INDESIT company

Model type:
AVSL85EU

Commercial code:
F029905

1140160 Exploded views

n1040325: New shock absorber fixing system with pin

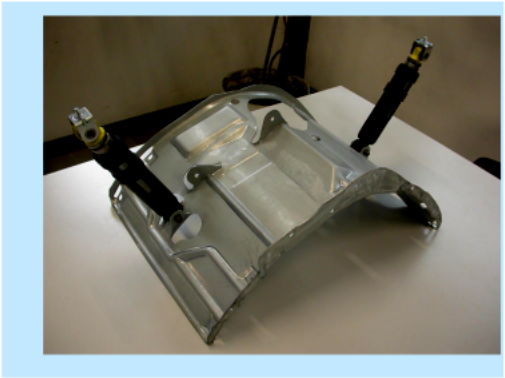
From serial no. 40427.0001, shock absorbers have been fixed to the tank unit cradle with two 11 mm pins code C00110163 (see fig. 01 and 02 enclosed) in place of the 8 mm screws code 093750 and relevant locking nuts code 030443, on all washing

machines and dryers produced in the Comunanza factory.
The items affected by this modification are:
1) The cradles have the same Service code, as they can be used in place of the new ones after widening the shock absorber fixing holes to a diameter of 10 mm.
Code 093848 - Tank unit cradle 46 lt
Code 093878 - Tank unit cradle 40 lt.
2) The new shock absorbers, with fixing bushing having no s/steel spacer, are not managed as they are interchangeable with the premodified items (make sure they are CIMA type, as the managed items), fixed with M8 screws code 093750 and related locking nut code 030443 (see figs. 05 and 06).
Code 093884 - Shock absorber 80 N
Code 093885 - Shock absorber 100 N

To remove the shock absorber from the tank, first extract the pin with a few hammer taps (see fig.03) until it is aligned with the tank bracket and then pull it out with a pair of pliers (see fig. 04).
(To refit the shock absorber use a new pin. Insert the pin until the toroidal edge is aligned with the bracket.)

n1040326: Two-bearing mechanism on Slim range washing machines

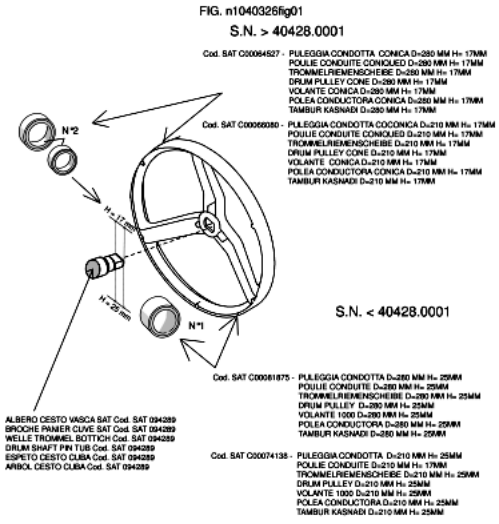
From serial no. 40428.0001, all Slim range models produced in the Comunanza factory have been equipped with a two-bearing mechanism in place of the single-bearing one.

The Service codes of the new mechanism are:
Service code C00096186 - SEAL RING CV4;
Service code C00002591 - BEARING 20X47X14 6204 SKF;
Service code C00013563 - BEARING 25 X52 X 15 6205 - 2Z SKF;
Service code C00110340 - CROSS WITH SEAL RING (2C) SNELLA;
Service code C00094289 - EVO 40L TANK SLIM (1-C) > (2-C)EVOII;
Service code C00094290 - OUTER- SET 40 L.(1-C)>(2-C)EVOII;
Service code C00064527 - DRIVEN PULLEY CONE D=280 MM H= 17MM;
Service code C00066080 - DRIVEN PULLEY CONE D= 210 MM H=17 MM.

The tank assembly with the new two-bearing cross has the same Service code as the single-bearing one (C00094289); the latter will be available until stocks run out.
When replacing the tank, make sure that the value H (17 mm or 25 mm) of the basket cross shaft corresponds to the value H of the pulley (see Fig.001).

Fig. n10402231

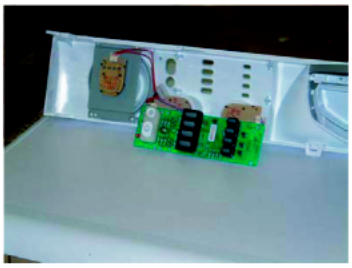
From serial no. 40429.0001, models AVL, AVXL, AVSL, AML have been equipped with a new panel with well holes for the ON/OFF and RESET buttons and flush plastic light diffusers in place of the projecting siliconed ones (see picture n10402231 Fig.02). These features determine whether an appliance is modified or premodification.
The modification has also involved the electronic card whose panel and display communication connectors are on the left and not at the back (see picture n10402232 Fig.2).

Fig . 001

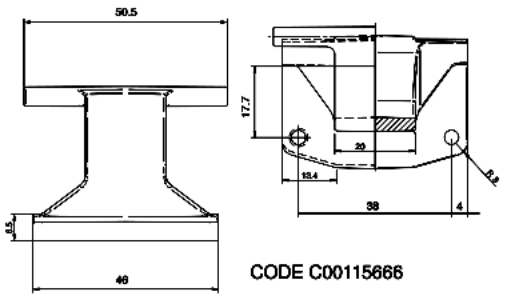
From serial no. 50207.0001, all Ariston models produced in the Teverola factory (see table 001 attached) with industrial code (given on the rating plate) starting with 46, have been equipped with a Zamac hinge with 150° opening angle, code C00115666 (see Fig.001).
This modification has involved the introduction of the following items:

Code C00115670 - Complete door EVOII 150° white 27 with standard glass;
Code C00115674 - Complete door EVOII 150° white 27 with long glass;
Code C00115667 - EVOII body for 150° hinge white 27;

The premodified items are not interchangeable separately with the modified ones.

Fig . 001

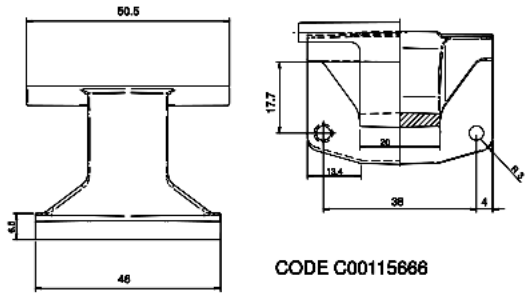
From serial no. 50207.0001, all Ariston models produced in the Comunanza factory (see table 001 attached) with industrial code (given on the rating plate) starting with 80, have been equipped with a Zamac hinge with 150° opening angle, code C00115666 (see Fig.001).
This modification has involved the introduction of the following items:

Code C00115670 - Complete door EVOII 150° white 27 with standard glass;
Code C00115674 - Complete door EVOII 150° white 27 with long glass;
Code C00115668 - Complete door EVOII 150° silver with standard glass;
Code C00115673 - Complete door EVOII 150° silver snella standard glass;
Code C00115662 - EVOII body for 150° hinge white 27
Code C00115663 - EVOII body for 150° hinge silver 27
Code C00115664 - Snella EVOII body for 150° hinge white 27
Code C00115665 - Snella EVOII body for 150° hinge silver

The premodified items are not interchangeable separately with the modified ones.
